**CITY OF FLORENCE, SOUTH CAROLINA
DESIGN REVIEW BOARD
FEBRUARY 10, 2021 AT 2:00 P.M. VIA ZOOM**

**DEPARTMENT OF PLANNING, RESEARCH & DEVELOPMENT
STAFF REPORT TO THE
CITY OF FLORENCE DESIGN REVIEW BOARD**

DATE: February 10, 2021
CASE NUMBER: DRB 2021-02
LOCATION: 137 East Palmetto Street
TAX MAP NUMBER: 90087-03-002
OWNER OF RECORD: Angelo Bakis
APPLICANT: Flavors of India – Madhur Chodda
PROJECT DESCRIPTION: Installation of Monument Sign
OVERLAY DISTRICT: Arts & Cultural Overlay District (D-3)

CASE NUMBER: DRB-2021-03

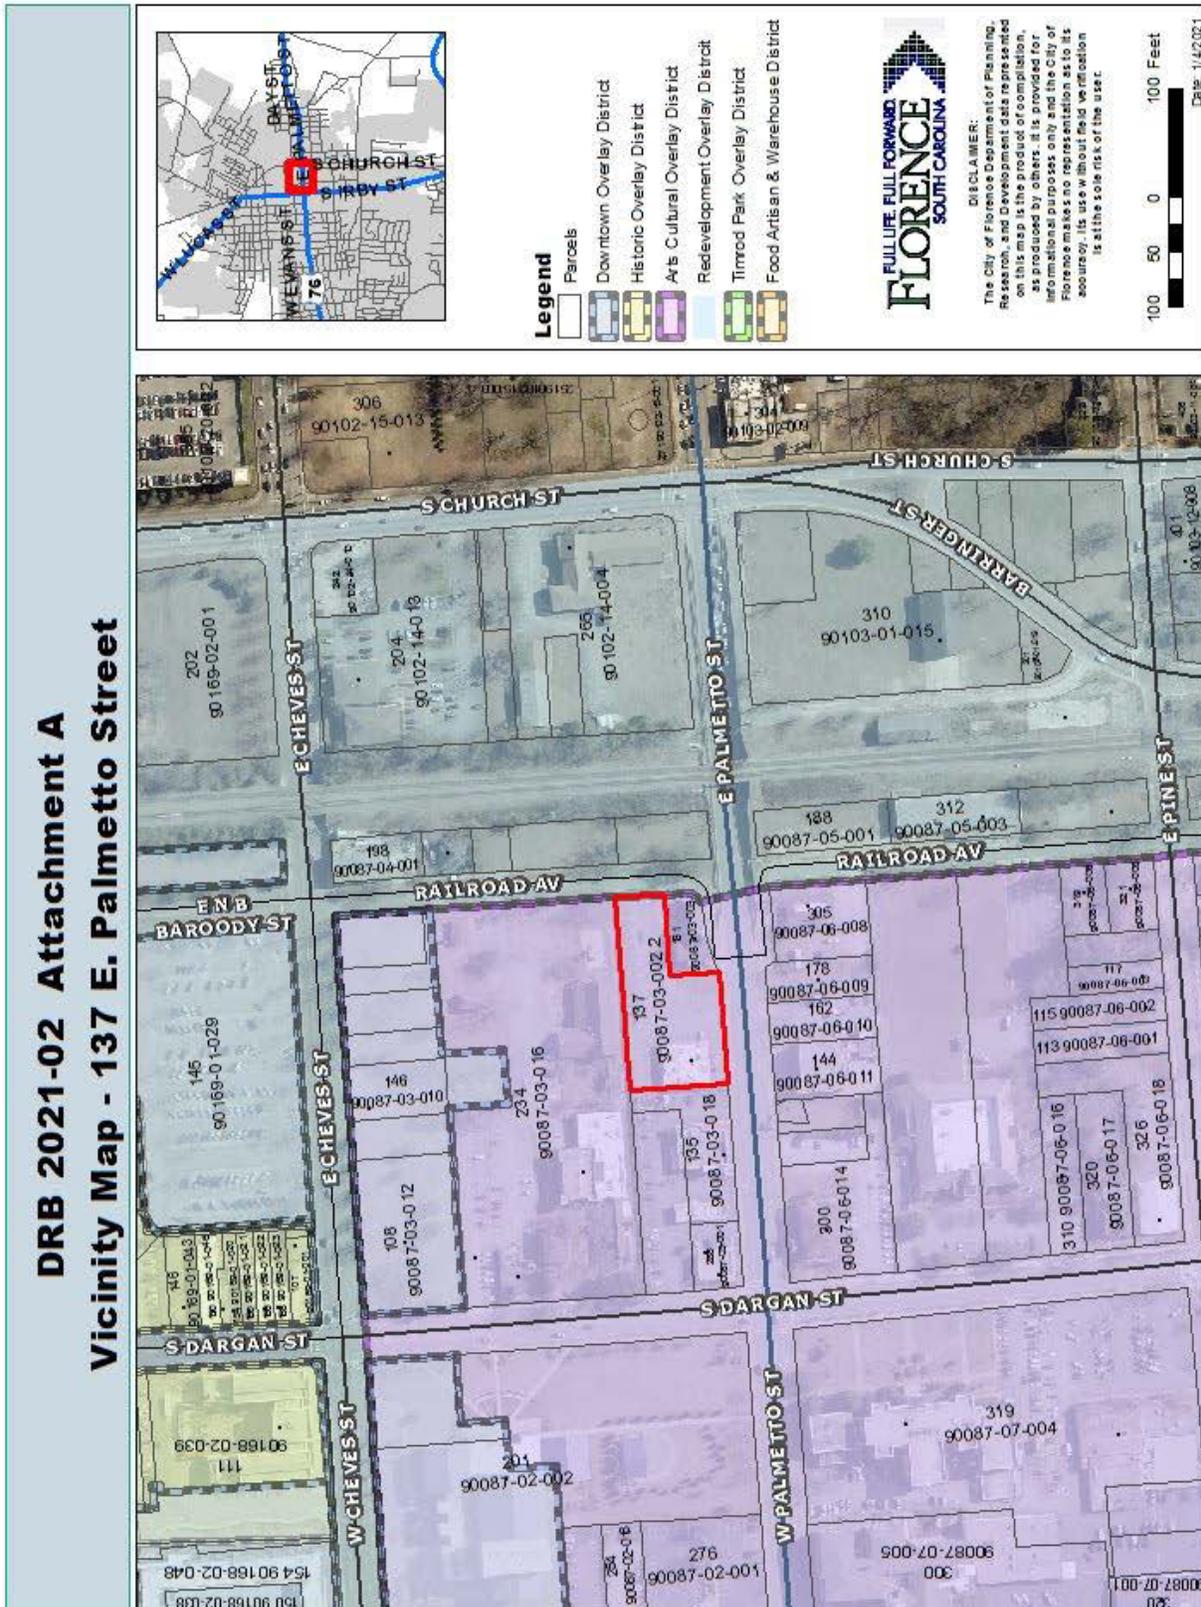
Location: The proposed Monument Sign (Attachment E) will be placed about 2' from the back of the sidewalk in the parking lot drive aisle along East Palmetto Street pictured in Attachment D. The Central Business District (CBD) permits one freestanding sign with a 0' setback from the property line with a maximum height of 24', and 80 square foot surface area. The placement of the sign will decrease the parking lot's drive aisle width along the front of the building, further restricting vehicular traffic. The restaurant currently has a drive aisle width of approximately 15'. This is in compliance with *Unified Development Ordinance* standards if traffic is limited to one-way. The drive aisle currently has no signage or road markings restricting the aisle to one-way. The minimum drive aisle width required for a parking lot with 60 degree parking stalls and two-way traffic is 22'. Placing the sign at the proposed location would be counter to Table 4-9.3.2 of the *Unified Development Ordinance* as attached below. If the sign is allowed in this location, an updated parking and vehicular access plan would need to be provided to meet the requirements of the *Unified Development Ordinance* and provide for a safe and efficient use of the parking lot.

The building was constructed in 1972, which might account for the smaller drive aisle width making it an existing non-conformity. At one time, the parking lot may have had signage restricting traffic to one-way instead of the existing two-way traffic. Further limiting the drive aisle width could lead to traffic problems that spill out onto East Palmetto Street.

The signage should not block vehicular visibility when entering or exiting the driveway. The proposed sign will be 6' in height, 6' in length, and 2' in width for a total square footage of 36', below the maximum permitted by the *Unified Development Ordinance*.

At the time of this report, the applicant had not provided details regarding materials or sign lighting. Backlit and internally lit signs may be used if approved by the Design Review Board and will be allowed only when they complement the existing façade and surrounding structures, and are consistent with the objectives of the Design Guidelines.

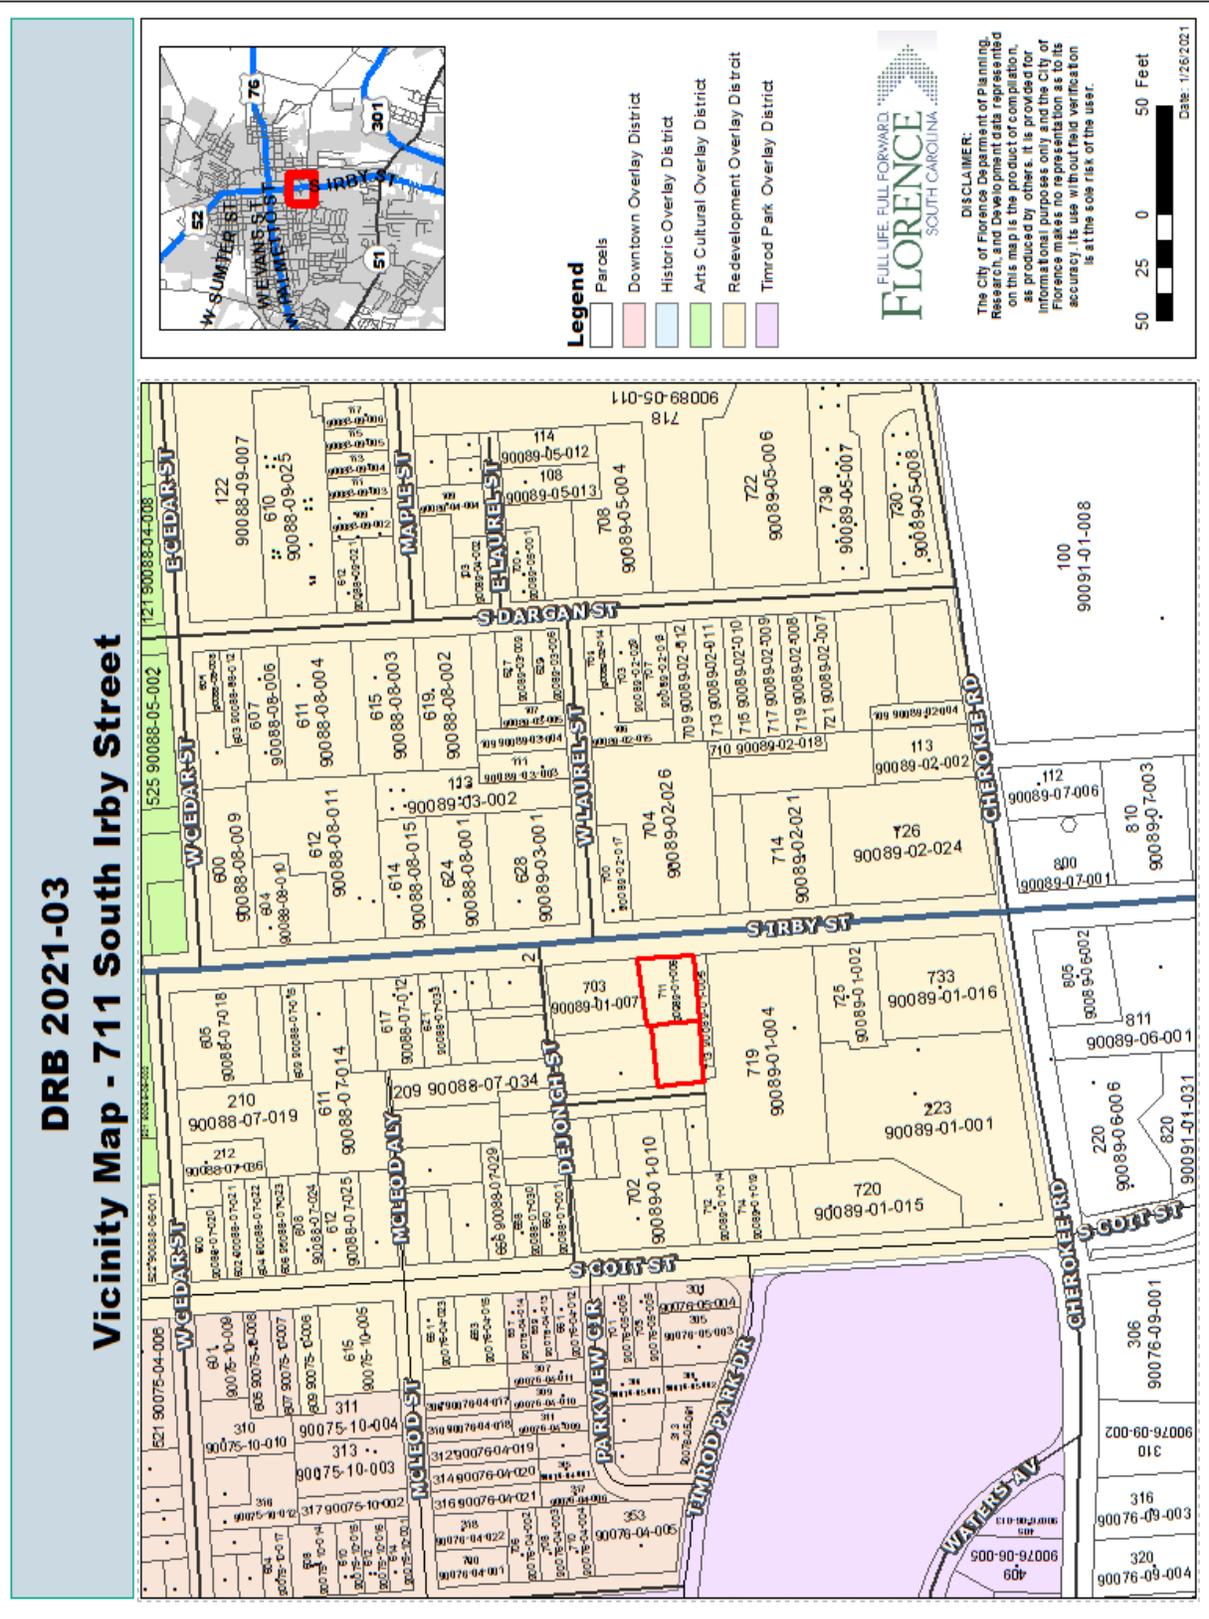
The previous building had no landscaping. The new building includes planted areas in front of the building and landscaped islands (Attachment E). There is also a trash dumpster enclosure, which was not part of the original building.

Previously there were twelve parking spaces in front and unpaved employee parking in the rear. There was a verbal agreement to use adjacent businesses' parking if necessary, which is still in effect per conversations with those owners (Attachment G). The new site has 27 parking spaces. The former building had no outside pickup window but the new one does. The ordinance requires 24 parking spaces.

Attachment F: Building Elevations

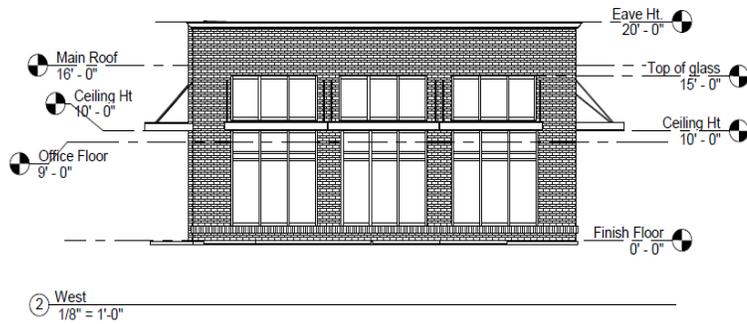
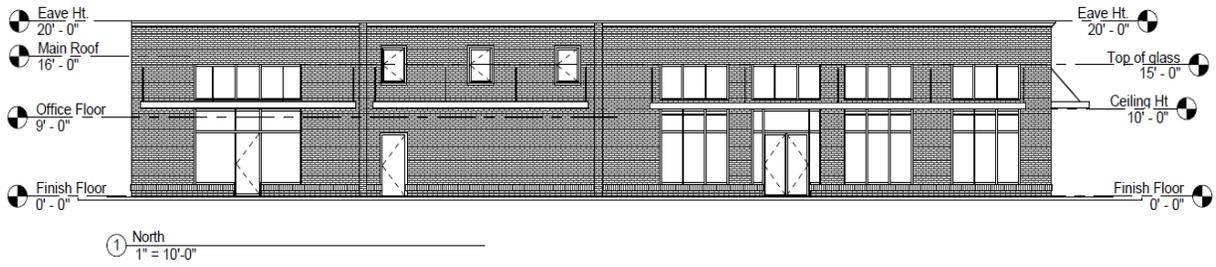
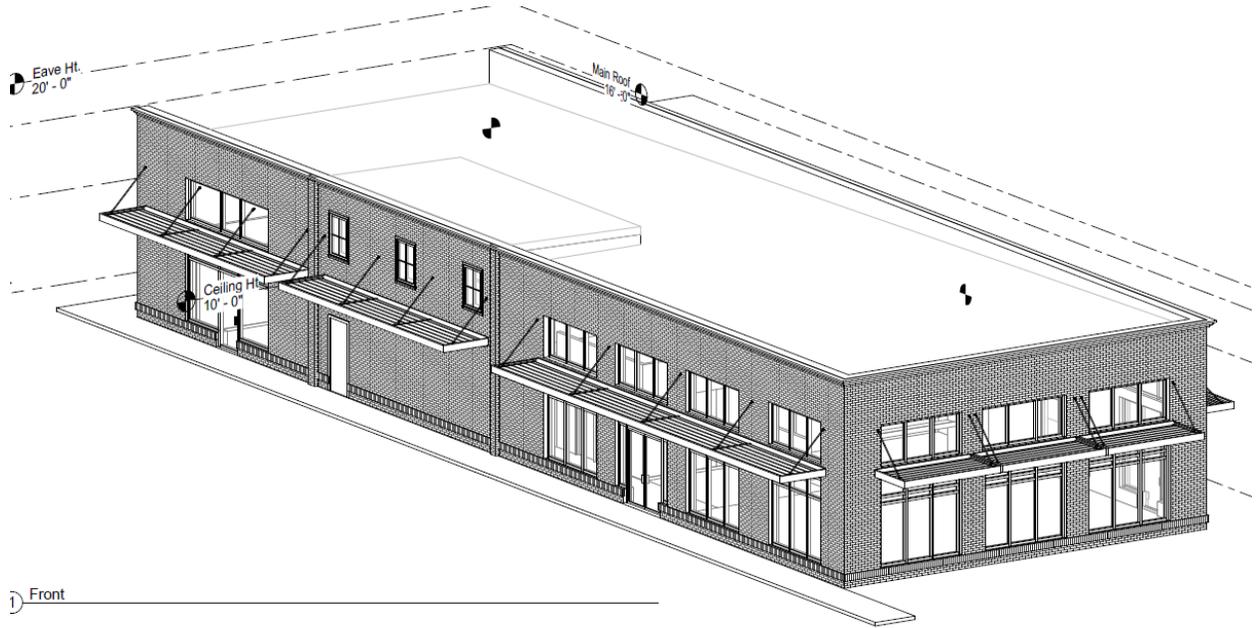
According to the applicant, the new building will be 4800 square feet whereas the original building was 7500 square feet in area. It will have a brick veneer using Blackmoore OS bricks by Pine Hall Brick Company (see Attachment F). The mortar will be a cream color. The EIFS wall coping will match the mortar color. All metal trim, aluminum canopies, and storefront framing will be matte black in color. The existing restaurant building sign will be mounted on the front wall and a new sign will be installed for the fish market. A sign will also be installed at the entrance to the restaurant.
